# AVALON DUPLEX

93 CENTRAL ROAD, AVALON NSW 2107

# FOR COMPLYING DEVELOPMENT

C	FOR CDC APPROVAL	22/2/2024
B	CONSULTANT COORDINATION	9/10/2023
A	FOR COMPLYING DEVELOPMENT	31/8/2023
P1	FOR CONSULTANT COORDINATION	22/8/2023
REV	STATUS	DATE

DRAWING TITLE: **ELEVATIONS (FRONT & REAR)**

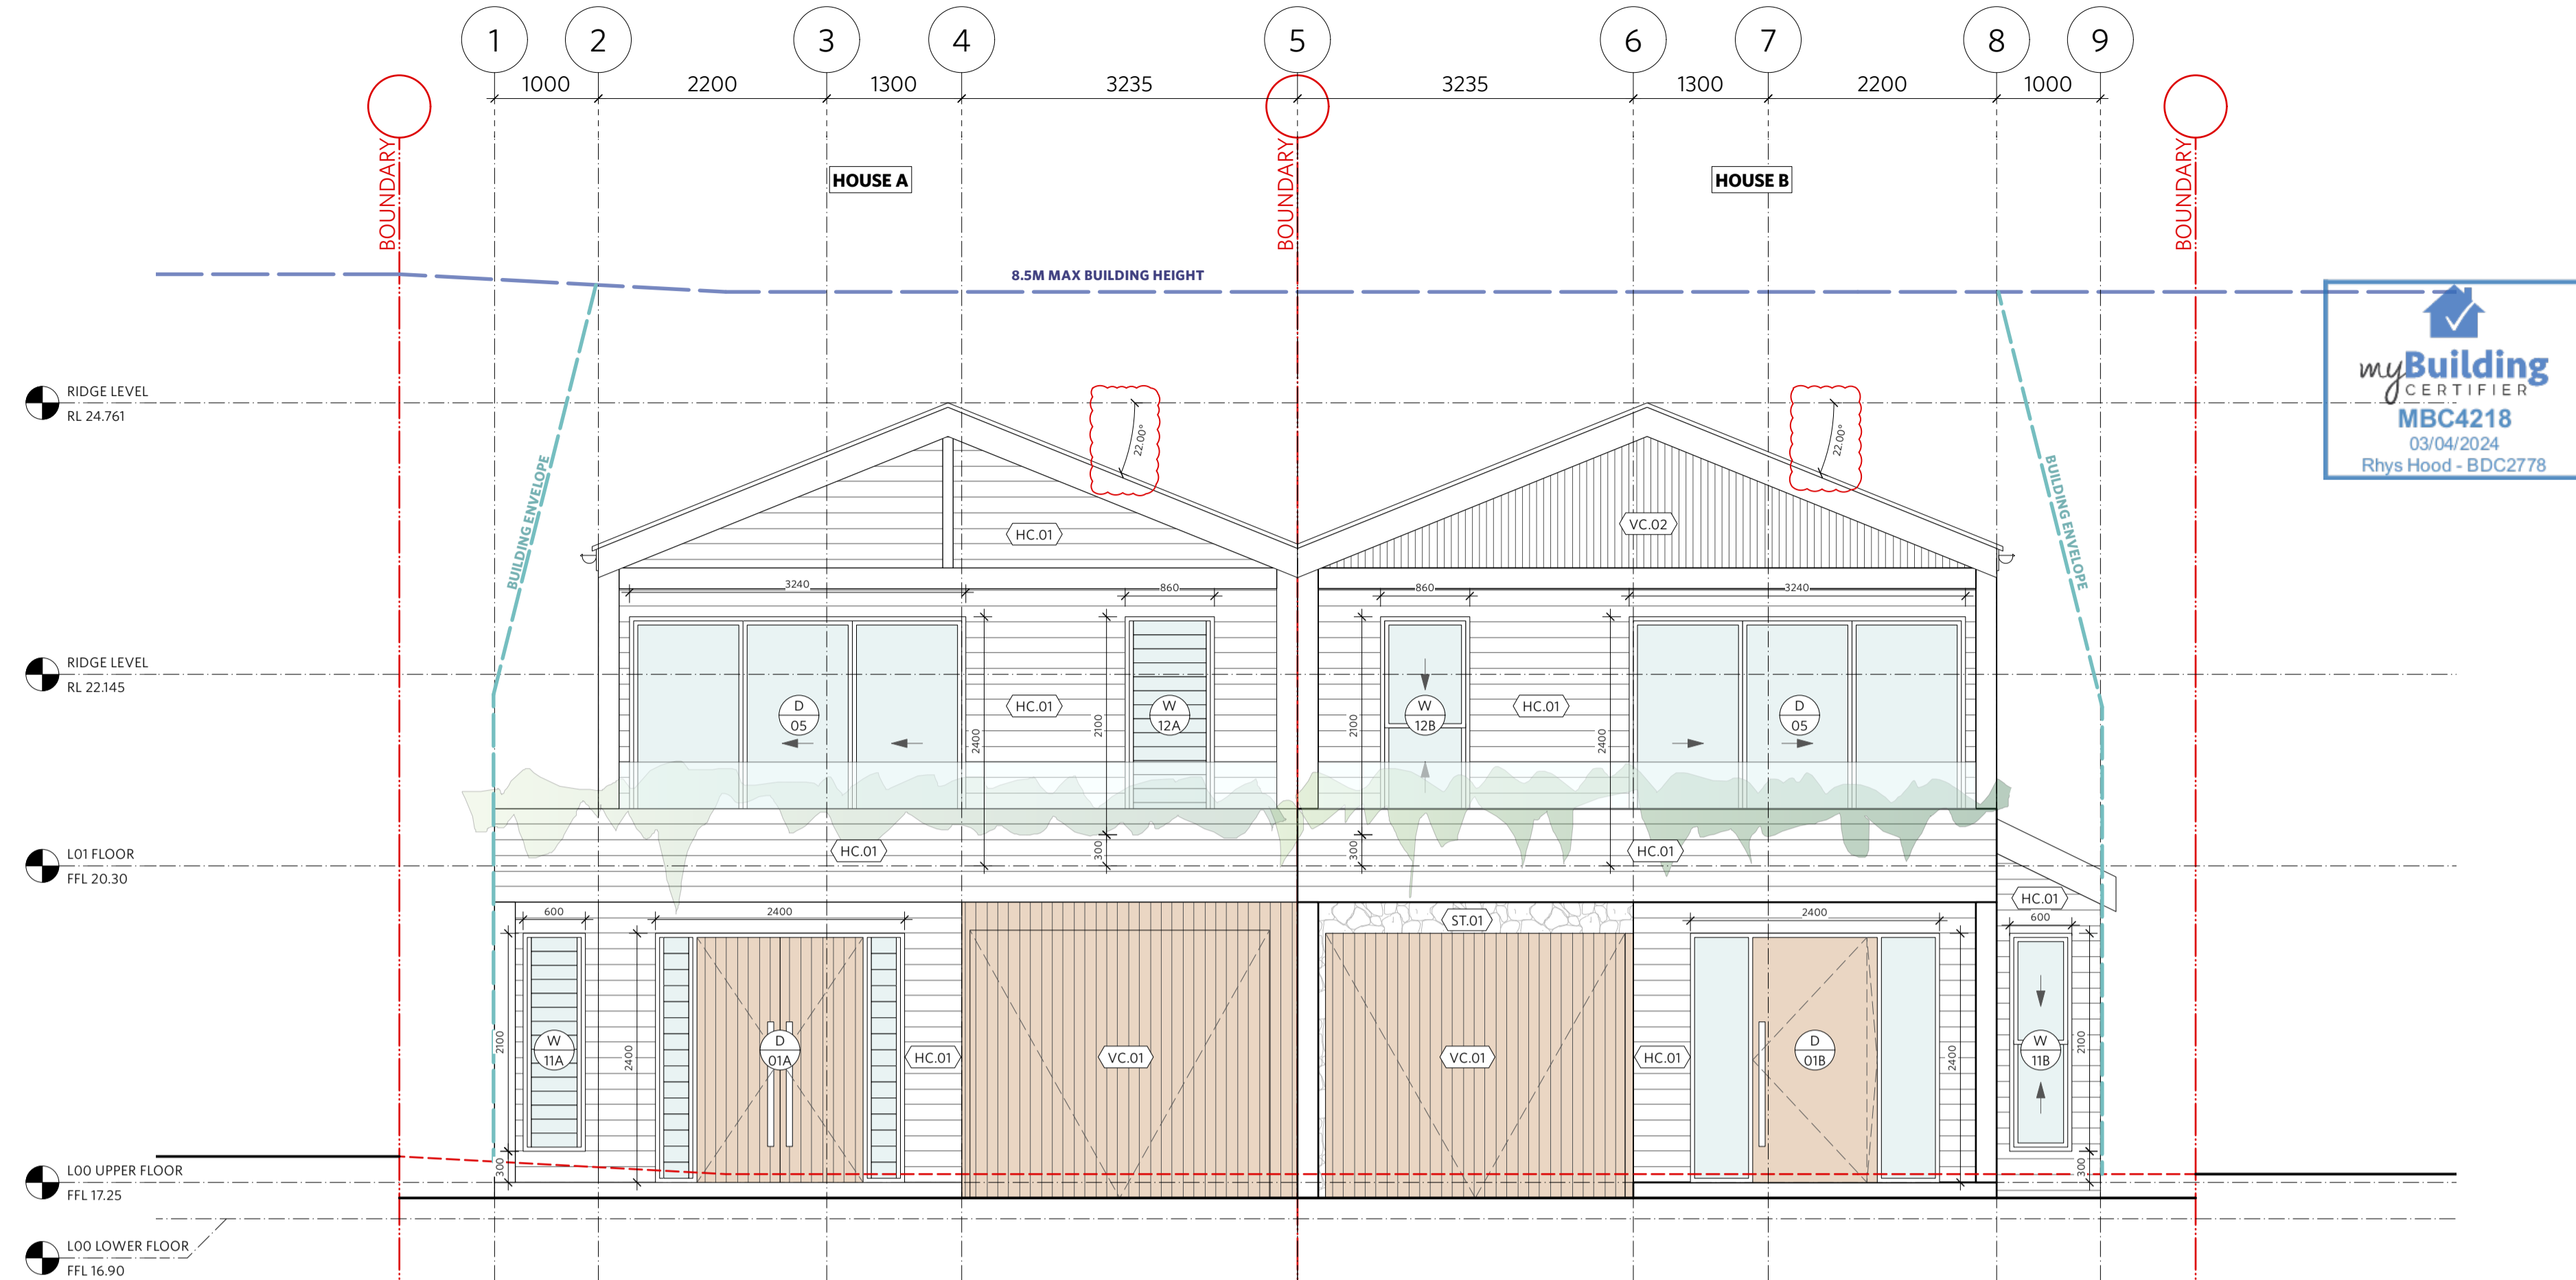
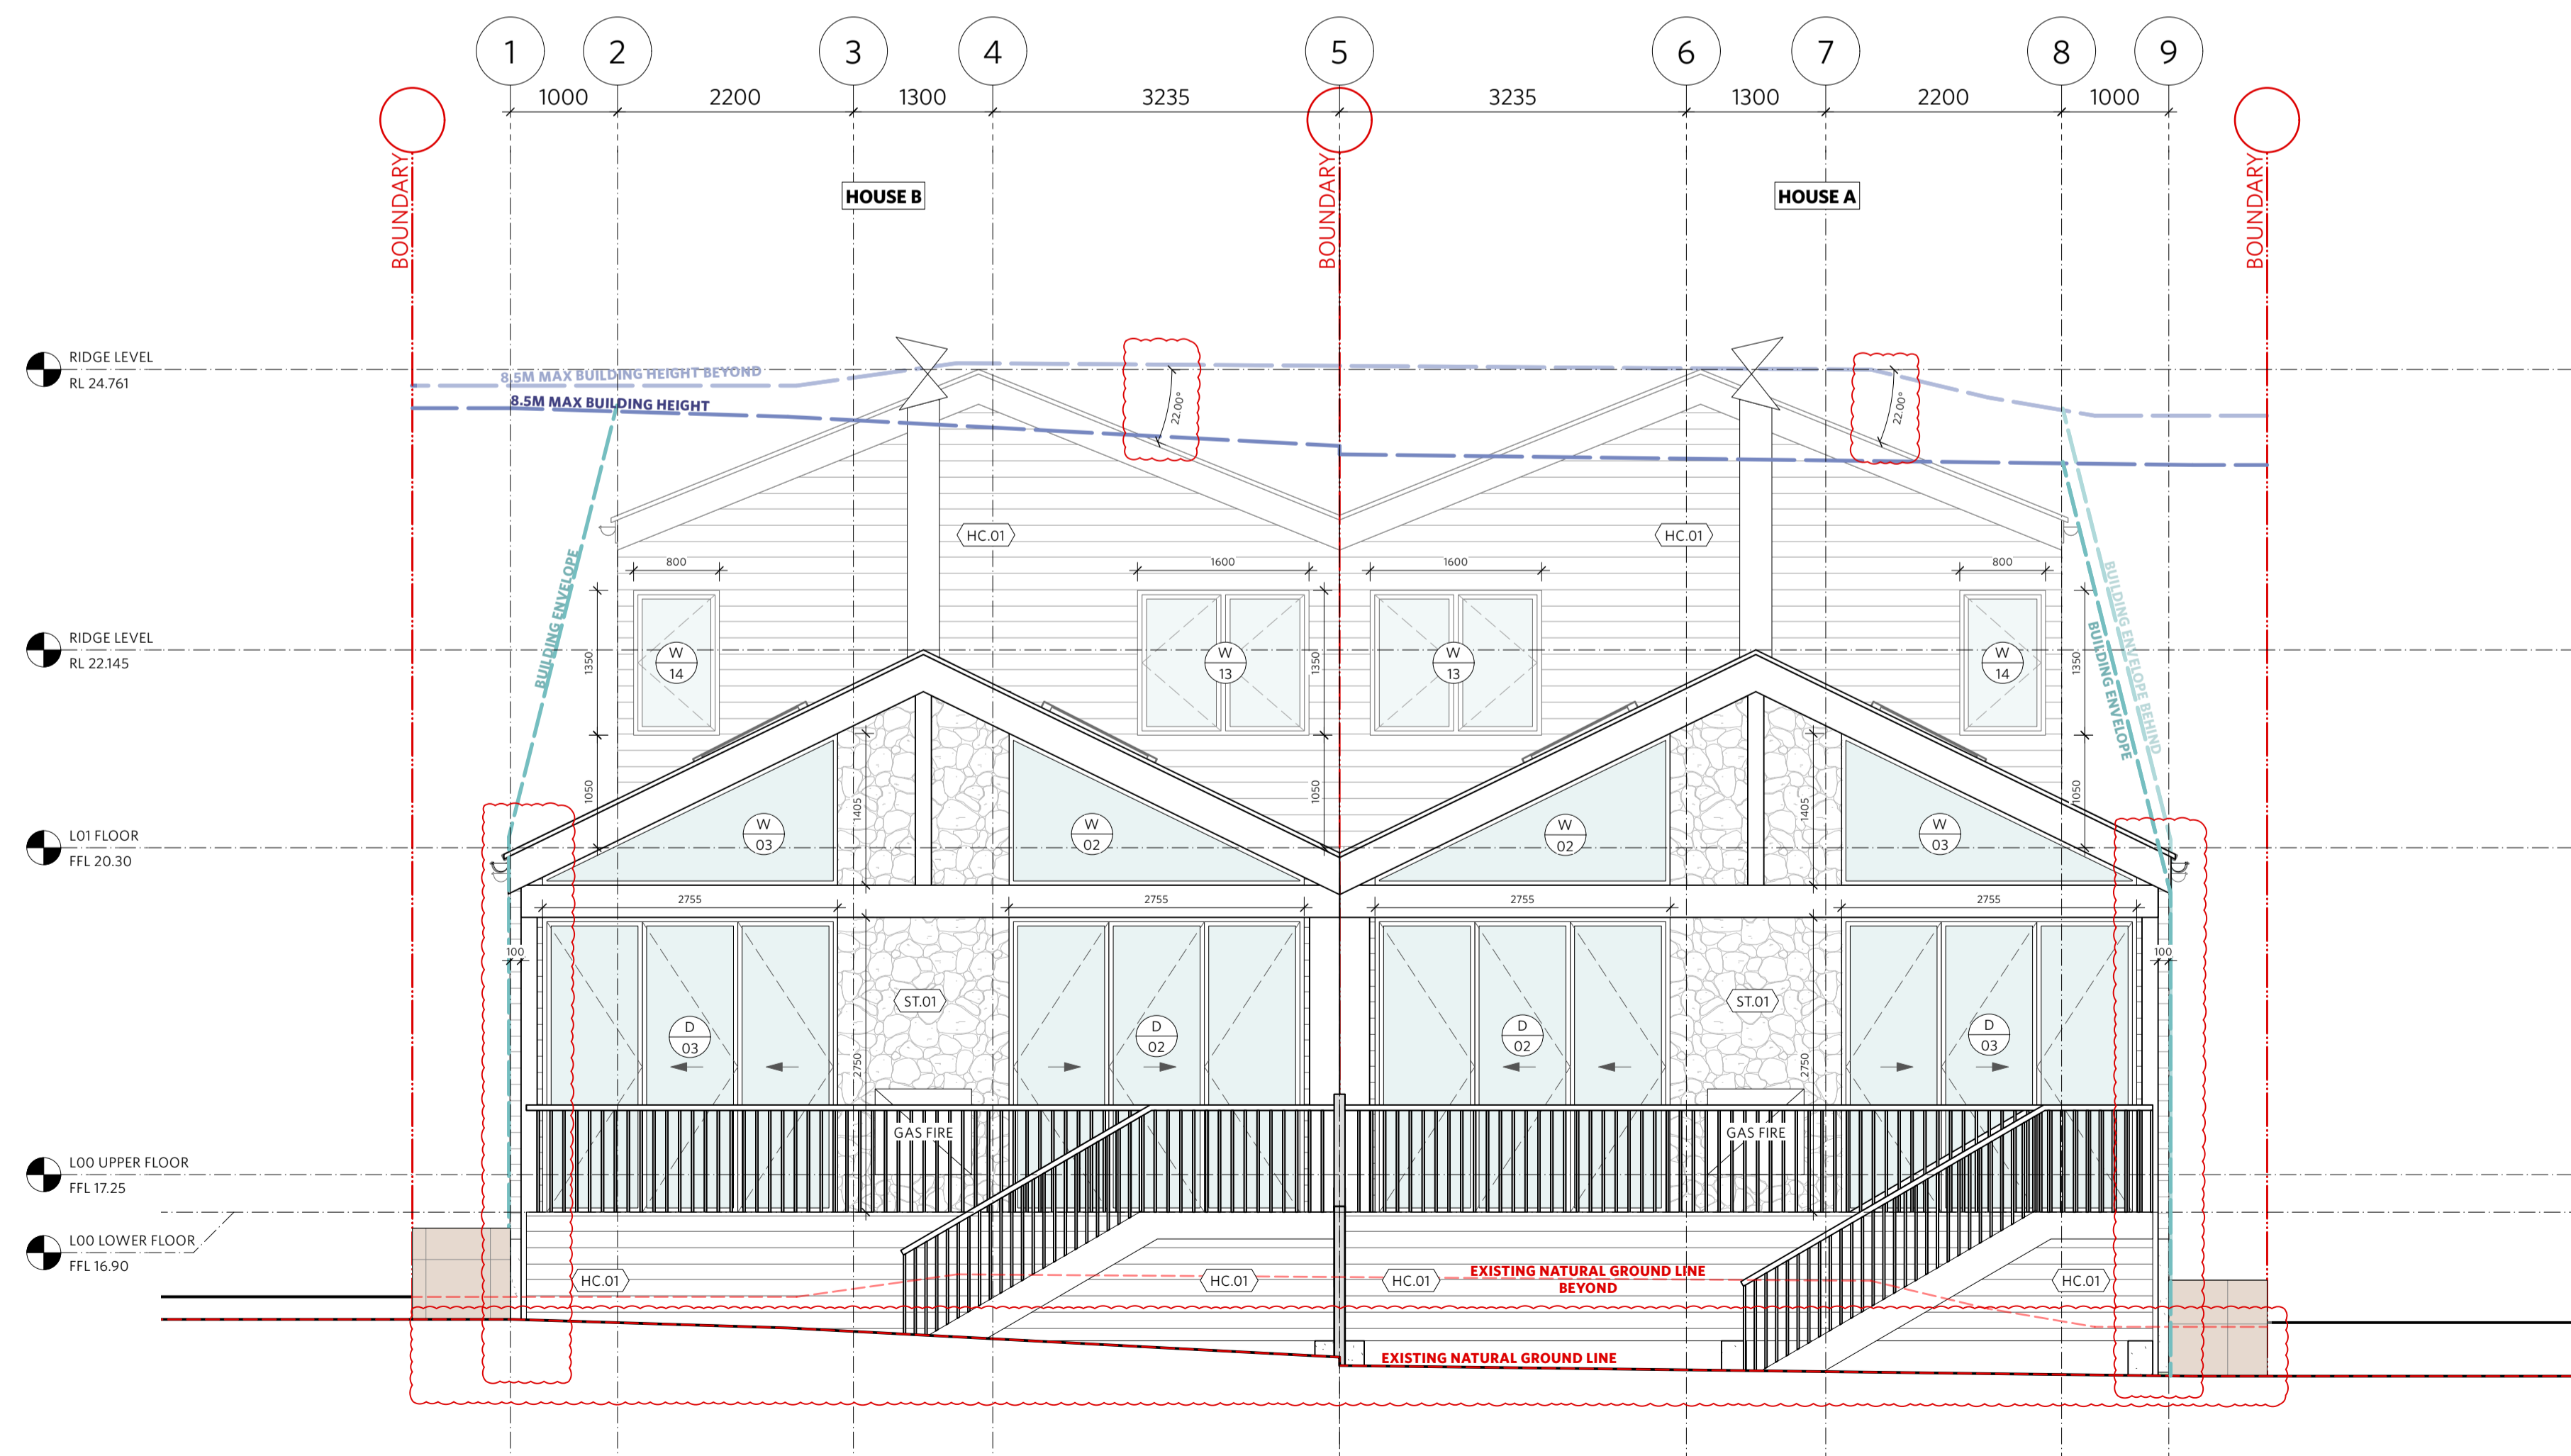
1) LOWER ROOF FALL CHANGED TO 27 DEGREES  
2) UPPER ROOF FALL CHANGED TO 22 DEGREES  
3) ALFRESCO WALL INSET 100MM

1 **STREETSCAPE ELEVATION**  
 1:50 @ A1

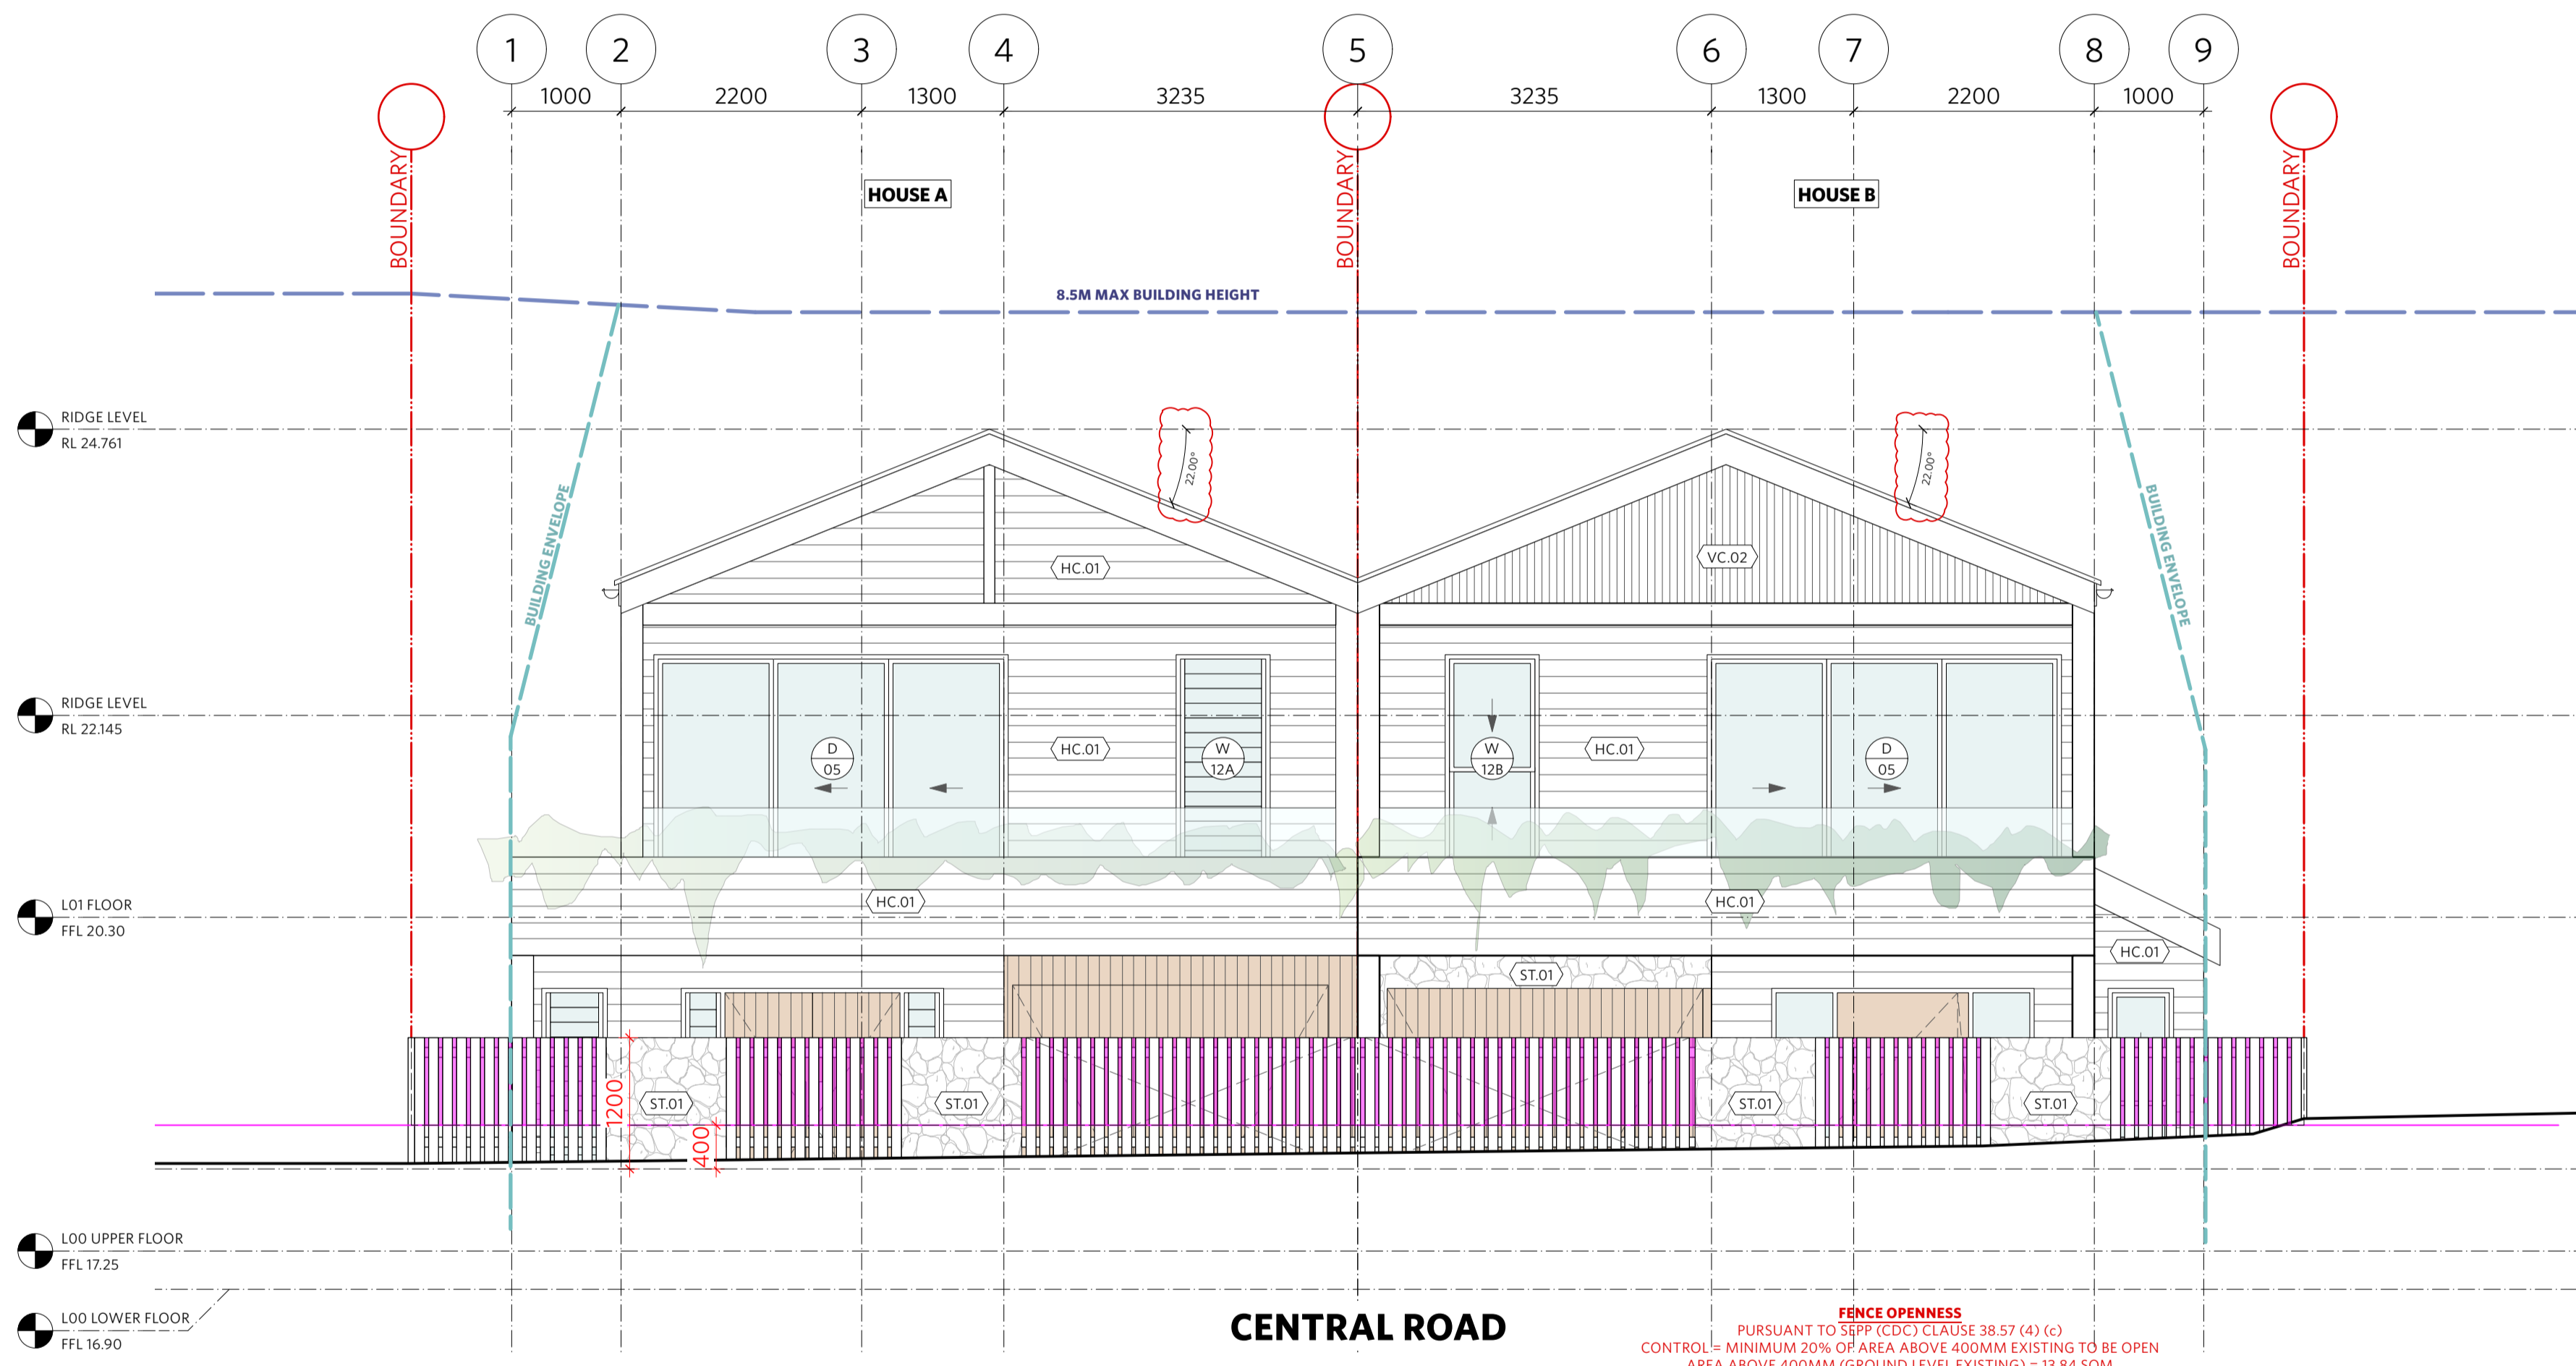
1) UPPER ROOF FALL CHANGED TO 22 DEGREES  
 2) FENCE OPENNESS CALCULATIONS ADDED
